1.0 APPLICATION SUMMARY

APPLICATION NUMBER: PRS 24-0219

BOCC LUM MEETING DATE: March 19, 2024

AGENCY REVIEW COMMENT SHEET

8.2 Proposed Site Plan (Full)

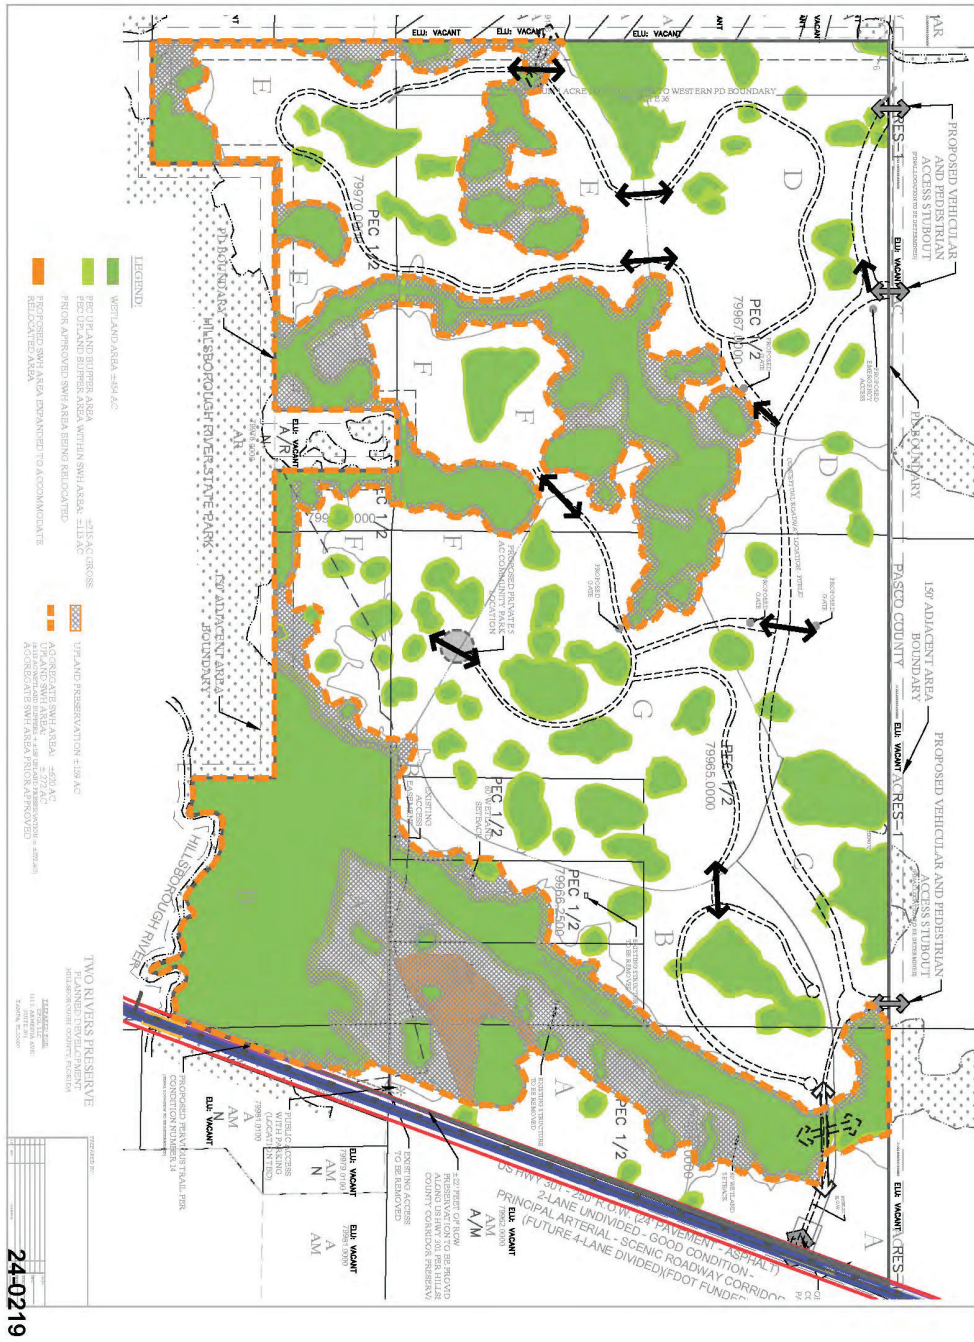
Prior to certification, the applicant shall make the following revisions to the PD site plan:

- Add an internal access double headed arrow showing access point(S) to development parcel "A" from the collector roadway to make clear on the PD site plan where access will generally be allowed.
- Revise the proposed PD site plan labeling "CONCEPTUAL ROADWAY LOCATION - PUBLIC" to say "CONCEPTUAL COLLECTOR ROADWAY LOCATION – PUBLIC"

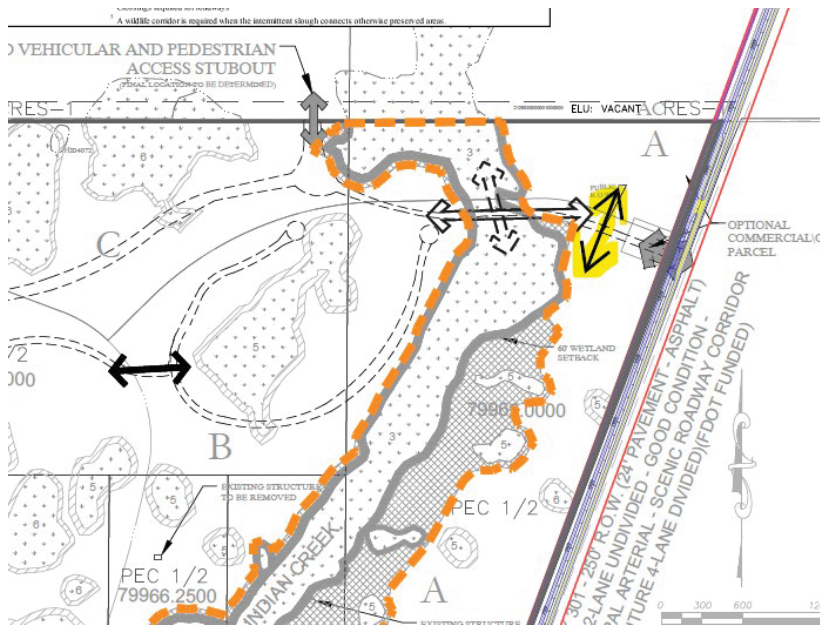
The access to US 301 will be served by a new east-west collector roadway, classified as a Type IV connection, proposed to be constructed by the developer and dedicated to the County. The new collector roadway is depicted conceptually on the PD site plan as the spine road connecting the internal development pods and stubbing out at three separate points to additional companion phases of development located with Pasco County and controlled by planned development zoning approved by the Pasco County BCC, case #RZ 7512, on September 15, 2021. The exact location of the three (3) stubout connections to Pasco County shall be determined at the time of site construction review in concert with the planned Pasco County phase.

The applicant's site access analysis indicates that the project's full access connection at US 301 meets warrants for a 680-foot northbound left turn lane and a 580-foot southbound right turn lane. As previously approved the applicant is committing to design and construct or bond a traffic signal at the primary access connection to US 301 subject to FDOT approval.

FDOT reviewed the proposed modifications on February 6, 2024 and indicated the projected proposed primary access to US Hwy 301 is in a location where FDOT's Planning Design and Environmental (PD&E) study (FPID#255796-1) anticipates FDOT stormwater ponds will be located. While the PD&E study is still in the process of adoption, FDOT comments recommend further coordination between the applicant and FDOT Drainage and Right of Way divisions. The applicant's proposed "Conceptual Project Access Location" will allow flexibility to reasonably shift the exact location of the access connection to US Hwy 301 if necessary to coordinate with FDOT.

Staff is recommending minor revisions to existing approved conditions to clarify the intended flexibility in the location of access and connection points as well as the identification of the planned roadway functional class, i.e. collector roadway, as discussed above in this section.

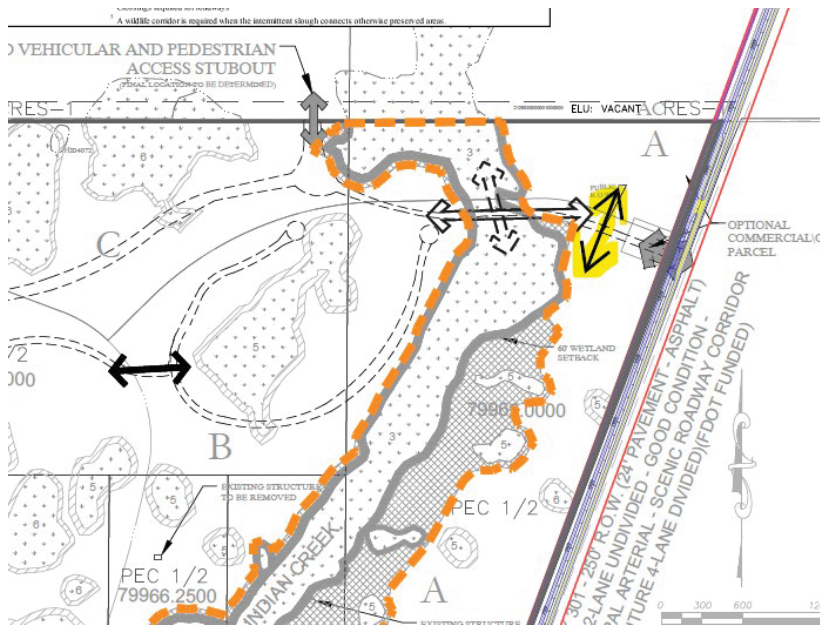
The access to US 301 will be served by a new east-west collector roadway, classified as a Type IV connection, proposed to be constructed by the developer and dedicated to the County. The new collector roadway is depicted conceptually on the PD site plan as the spine road connecting the internal development pods and stubbing out at three separate points to additional companion phases of development located with Pasco County and controlled by planned development zoning approved by the Pasco County BCC, case #RZ 7512, on September 15, 2021. The exact location of the three (3) stubout connections to Pasco County shall be determined at the time of site construction review in concert with the planned Pasco County phase.

The applicant's site access analysis indicates that the project's full access connection at US 301 meets warrants for a 680-foot northbound left turn lane and a 580-foot southbound right turn lane. As previously approved the applicant is committing to design and construct or bond a traffic signal at the primary access connection to US 301 subject to FDOT approval.
